**NEW YORK STATE THRUWAY AUTHORITY
DEPARTMENT OF ENGINEERING**

**ALBANY, NY
JANUARY 30, 2024**

**AMENDMENT NO. 2
TO**

**CONTRACT TAA 23-25B
D214941
THRUWAY BRIDGE REHABILITATION
OVER THE WALLKILL RIVER, MP 81.72
IN THE ALBANY DIVISION
OF THE NEW YORK STATE THRUWAY
IN ULSTER COUNTY**

SECTION A-A AT APPROACH
AND SLEEPER SLAB

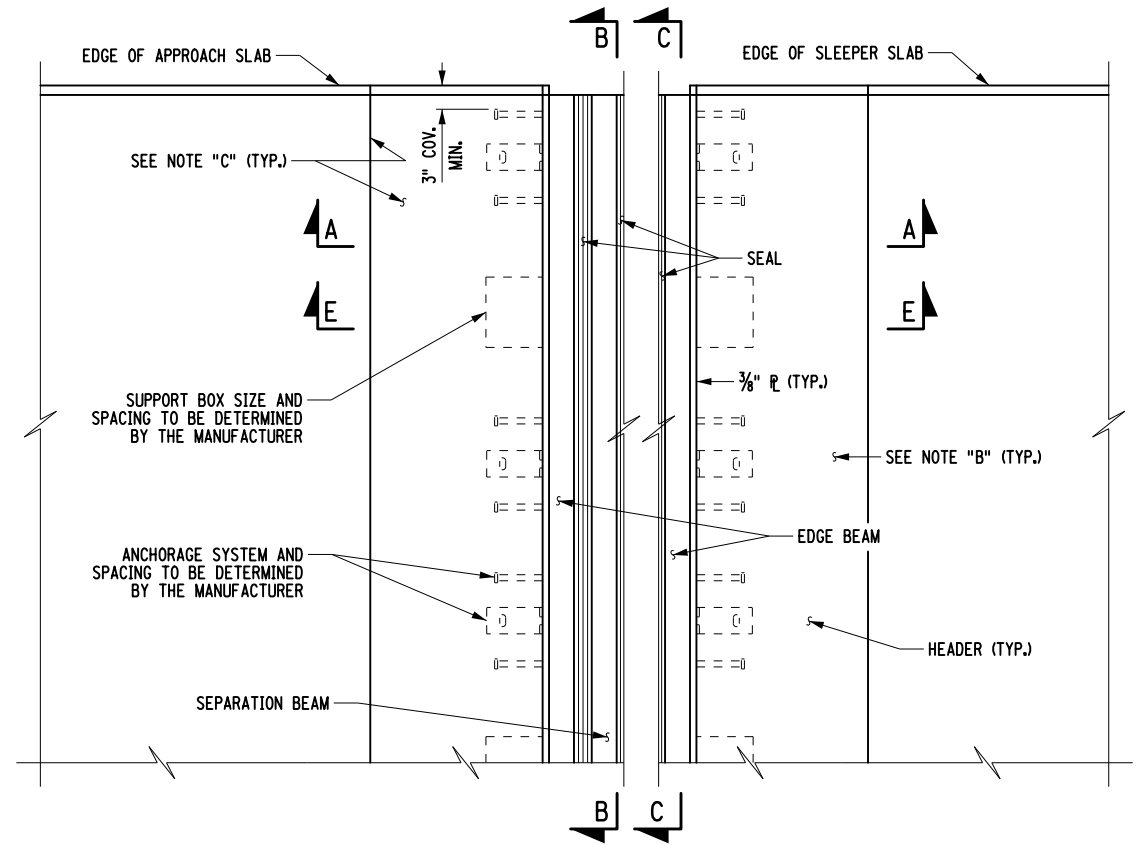
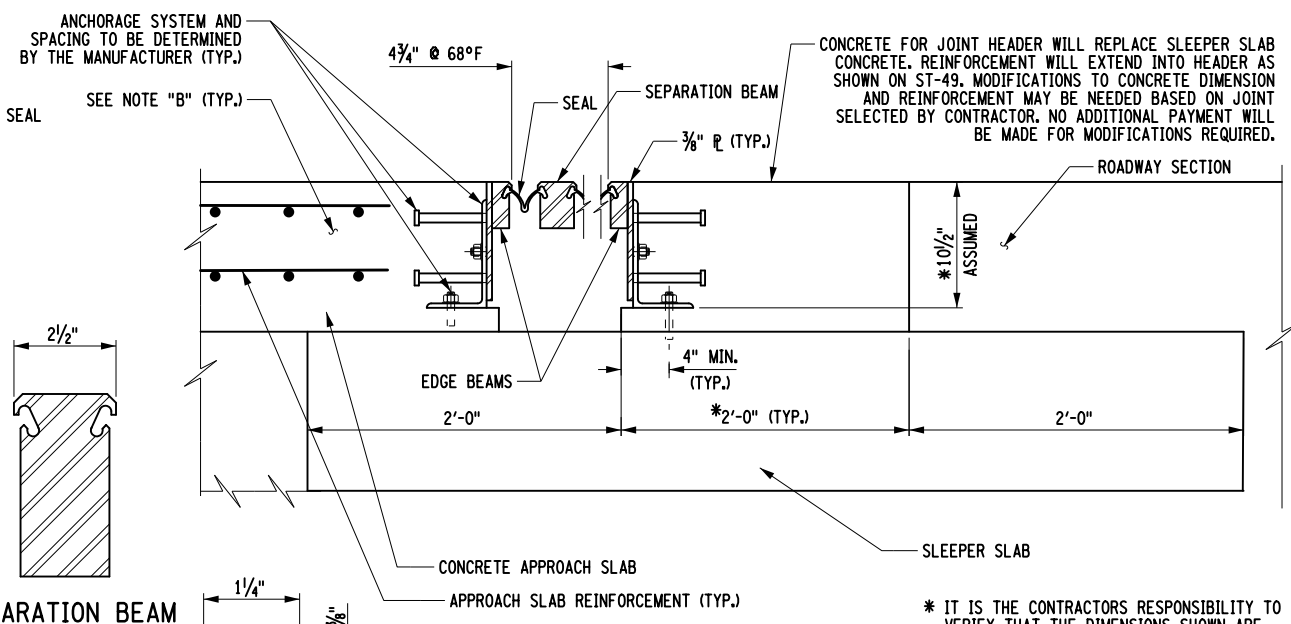
- A Note was added to Section A-A for the At Approach and Sleeper Slab Detail regarding the header concrete for the modular joint
55. **CHANGE** Drawing Number ST-57, Sheet 98 of 105, **DELETE** existing Note **3**, and **REPLACE** with the following Note **3**. "CONCRETE ANCHORS MUST HAVE A WORKING CAPACITY OF A COMBINED **5** KIPS IN SHEAR AND **12** KIPS IN TENSION.". The temporary concrete tie-downs angle size and concrete anchor loads are now provided.

THIS SHEET SUPERSEDES SHEET 99
IN ITS ENTIRETY

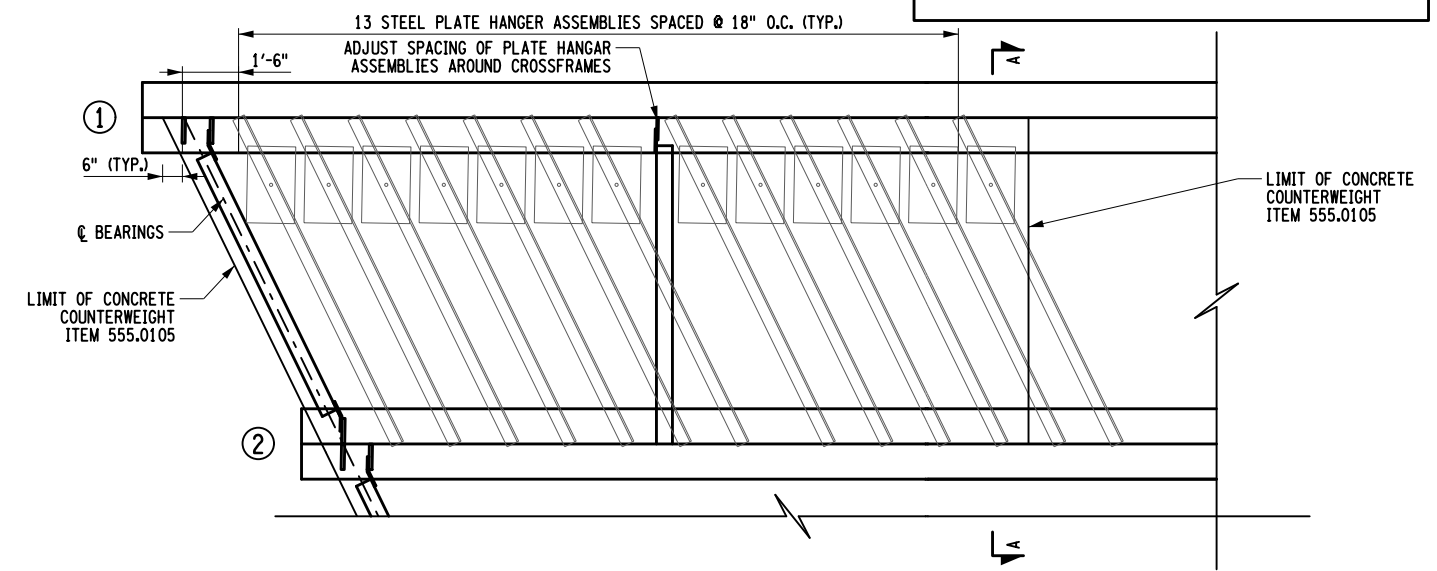
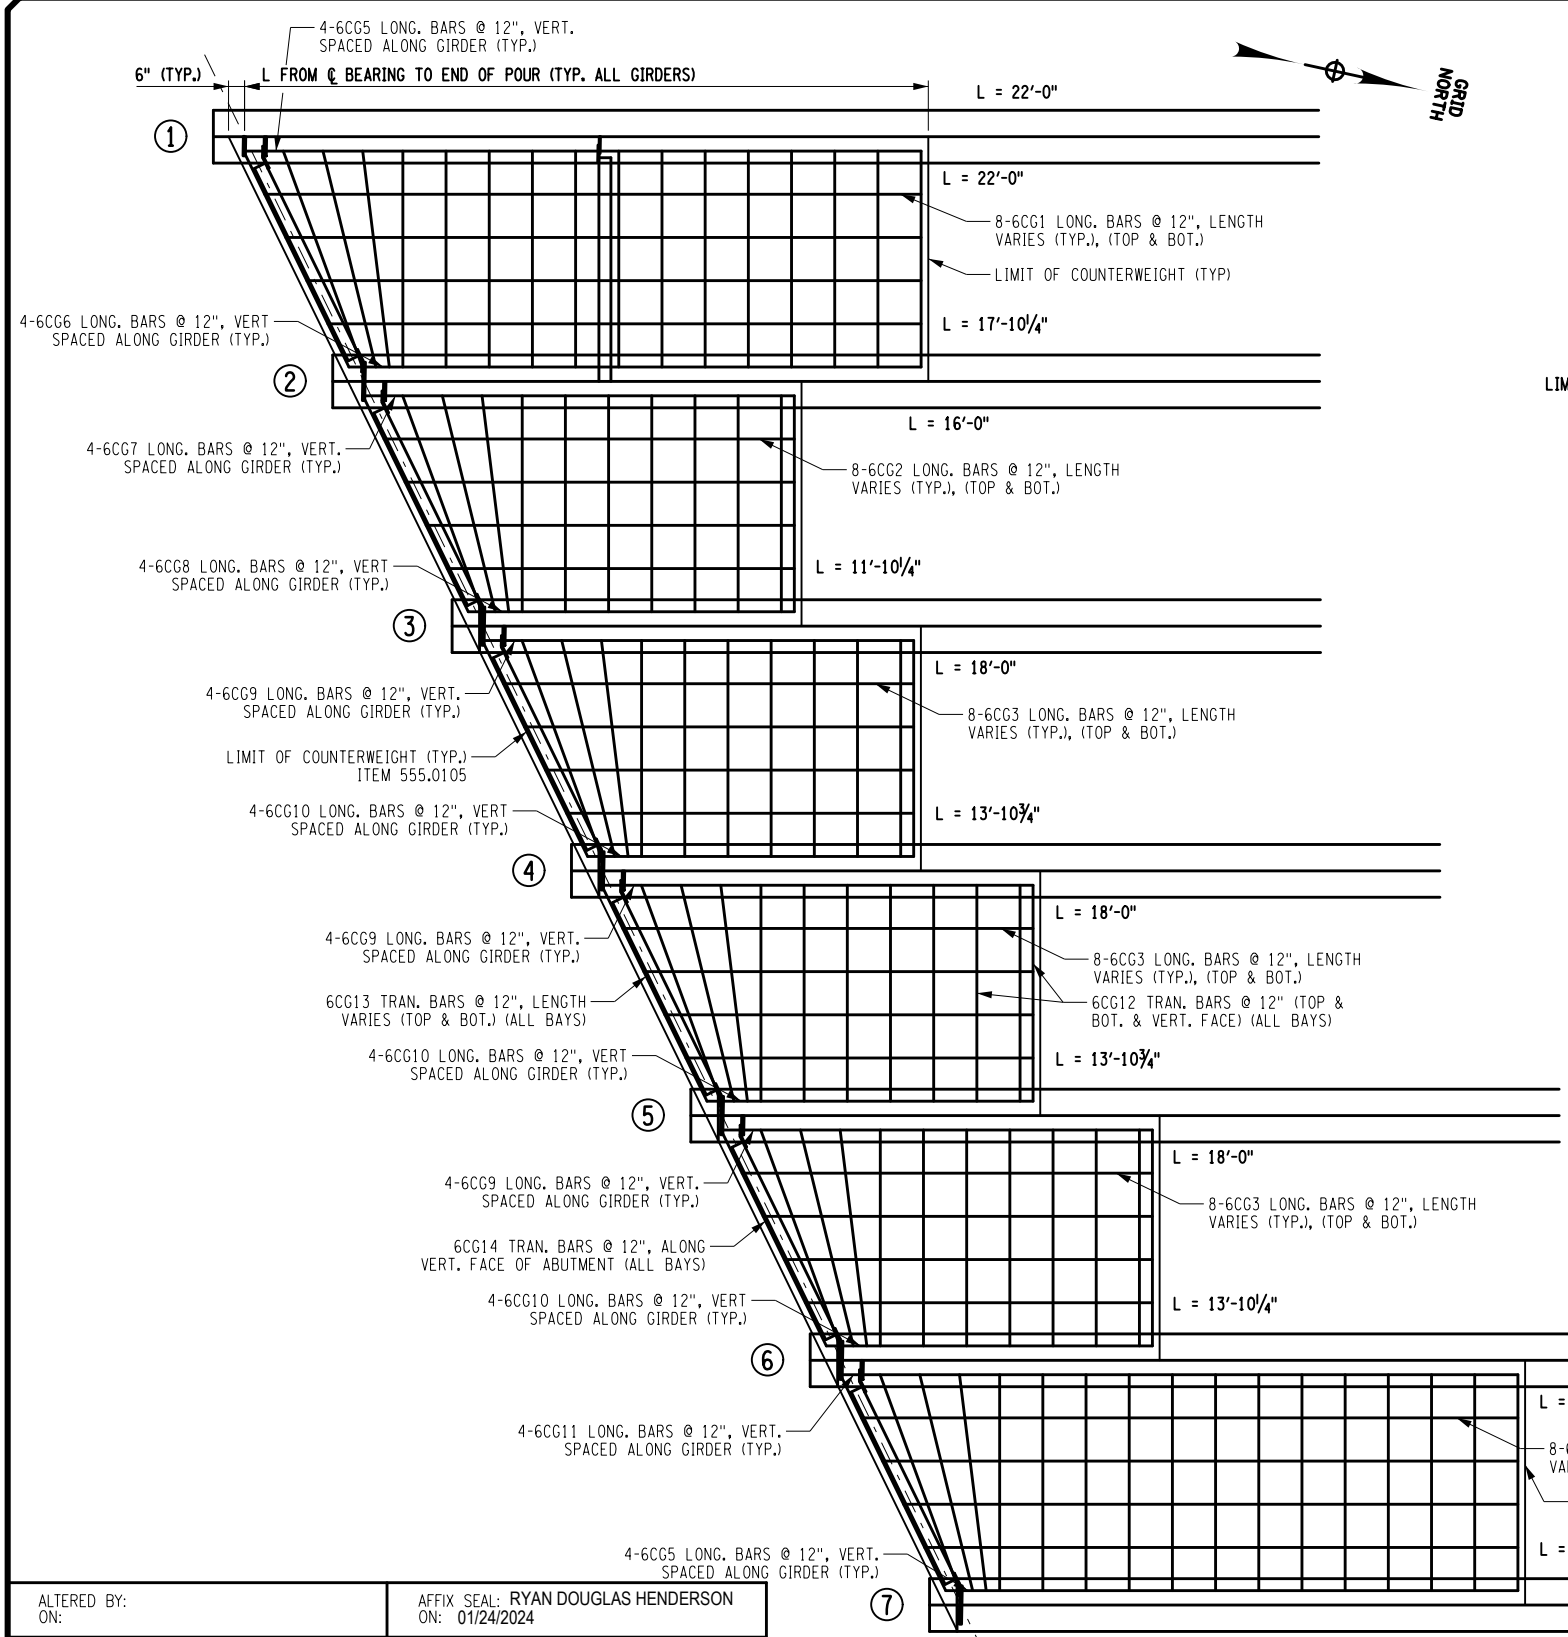
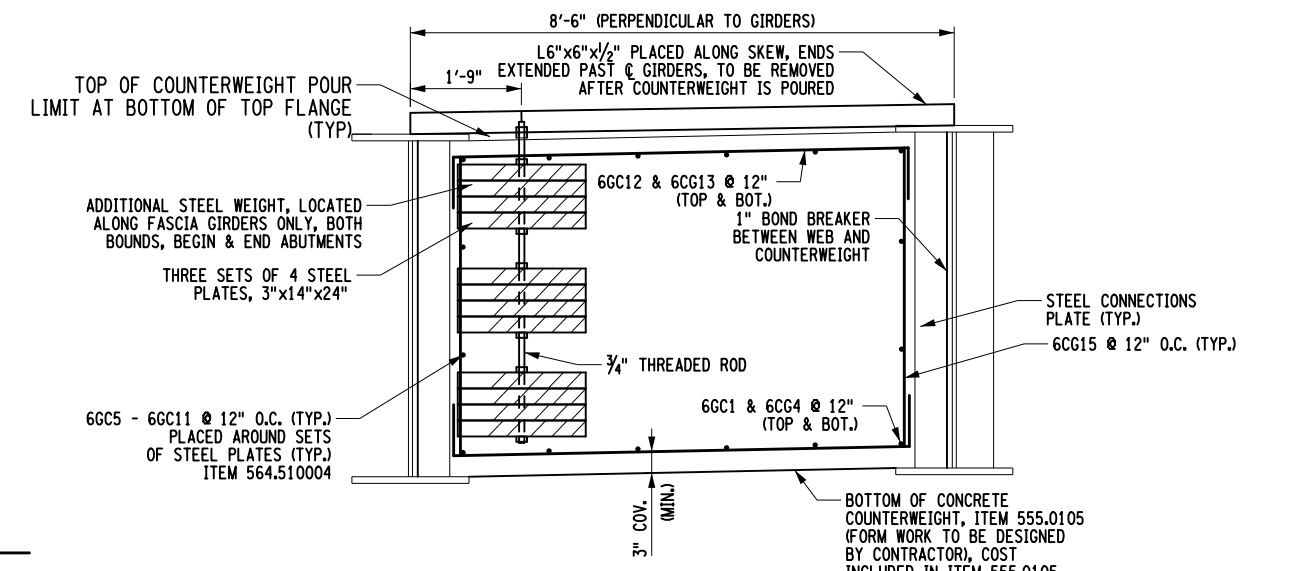
56. **DELETE** Drawing Number ST-58, Sheet 99 of 105 and **REPLACE** with the attached new Drawing Number ST-58-A2, Sheet 99-A2 of 105.
 - A previous reference to a Section A-A (between one and two, near the top left corner) has been removed from the Concrete Counterweight Layout Plan

- Note 4 has been updated to correct the pay item for the formwork to place the concrete for the counterweight. This work is now to be included under Item 555.0105, Concrete for Structures, Class A.
